**SYDNEY CENTRAL CITY PLANNING PANEL
MODIFICATION OF CONSENT**

Panel Reference	2019CCI011
DA Number	DA/485/2016/A
LGA	City of Parramatta Council
Proposed Development	Section 4.55(2) modification to approved mixed use development, specifically modification of Conditions 1 and 15 of Schedule 2 to allow for provision of an increased number of car parking spaces on site. The application will be determined by the Sydney Central City Planning Panel.
Street Address	44-48 Oxford Street, EPPING NSW 2121 (Lots A & B DP 390454, Lots 1 & 2 DP 206646)
Applicant	Pirasta Pty Ltd
Owner	Pirasta Pty Ltd
Date of DA lodgement	12 December 2018
Number of Submissions	3
Recommendation	Refusal
Regional Development Criteria (Schedule 4A of the EP&A Act)	Pursuant to Clause 21 of State Environmental Planning Policy (State and Regional Development) 2011, the proposal is a Section 4.55(2) modification to an application with a capital investment value of more than \$20 million (criteria at time of lodgement).

Figure 3. Applicant Basement Level 4 Plan as submitted prior to determination of original application (left) and Revised Basement Level 4 Plan (right). Changes are highlighted in red. The full sized drawings are included at Attachments 3 and 4 respectively.

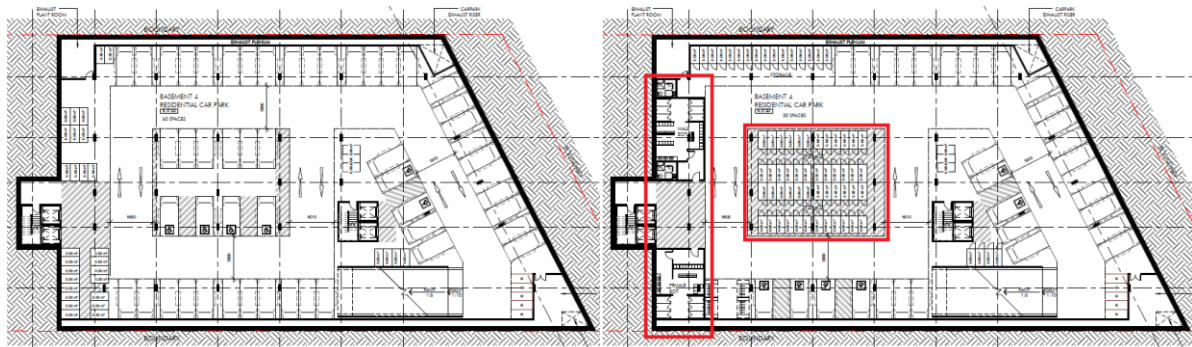
Revise the approved drawing list to refer to an updated drawing for basement level 4 which provides end-of-trip facilities and a total of 203 spaces (taking into account the parking on the other basement levels).

The original drawings included 223 spaces. The proposal would not result in any change to the envelope of the basement, but rather would replace 20 of the originally proposed car parking spaces with end-of-trip facilities and storage.

The applicant also seeks modification to the 'mix' of uses for the parking spaces (see Table 1 above). The applicant's proposed mix is based on the DCP recommended rates (See Attachment 1). The proposal would result in a total of 52 more spaces for residential occupants, the type of spaces most likely to generate trips during peak traffic times. As the RMS CBD rates are considered to be applicable, and thus supersede the DCP rates, it is not considered appropriate for the mix to be changed as proposed.

The application also seeks to modify condition 15 by way of deleting the requirement for end-of-trip facilities. However, the revised drawings proposed as part of condition 1 include the end-of-trip facilities. As such this element of the modification would be considered acceptable.
